Access Compliance Report

Public Rights-of-Way

(Curb Ramps)

Intersection ID: 29810	Main Street: MCCLURE_MANOR_DR	Cross Street: SYDENHAM_CT	Location: SW
ADA ID: 6067F8D7BAD6	Ramp Type: Perp	Initial Pass/Fail: Fail	Overall Compliance: No
Severity Score: 25			
Codes/Mitigation Info/Possible Solution		Field Measurements/Component Compliance

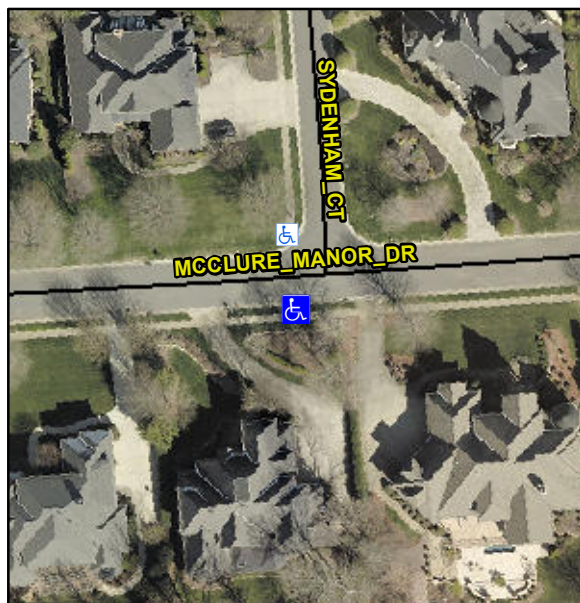
Not Found, R304.5.3

Compliance	Description	Data	Compliance	Description	Data
N/A	Ramp Length (in)	47.0	Yes	Ramp Slope (%)	8.0
Yes	Ramp Width (in)	53.0	No	Ramp XSlope (%)	8.2
N/A	Flare Type LT	N/A	N/A	Flare Type RT	N/A
N/A	Flare Slope LT (%)	N/A	N/A	Flare Slope RT (%)	N/A
N/A	Flare Traversable LT?	N/A	N/A	Flare Traversable RT?	N/A
N/A	Landing Length (in)	N/A	N/A	DWS Provided?	N/A
N/A	Landing Width (in)	N/A	N/A	DWS Contrast?	N/A
N/A	Landing Slope (%)	N/A	N/A	DWS Length (in)	N/A
N/A	Landing X Slope (%)	N/A	N/A	DWS Full Width?	N/A
N/A	Landing Curb? (Y/N)	N/A	N/A	DWS Offset (in)	N/A
N/A	Shared Landing?	N/A			
N/A	Gutter Ponding?	N/A	N/A	Gutter Slope (%)	N/A
N/A	Gutter Lip Ht (in)	N/A	N/A	Gutter X Slope (%)	N/A
N/A	Painted X Walk1?	No	N/A	Painted X Walk2?	N/A
	X Walk 1 Direction	To N		X Walk 2 Direction	N/A
N/A	X Walk 1 Width (in)	N/A	N/A	X Walk 2 Width (in)	N/A
	X Walk 1 Slope (%)	0.2		X Walk 2 Slope (%)	N/A
	X Walk 1 X Slope (%)	7.0		X Walk 2 X Slope (%)	N/A

Remove & Replace Entire Ramp.
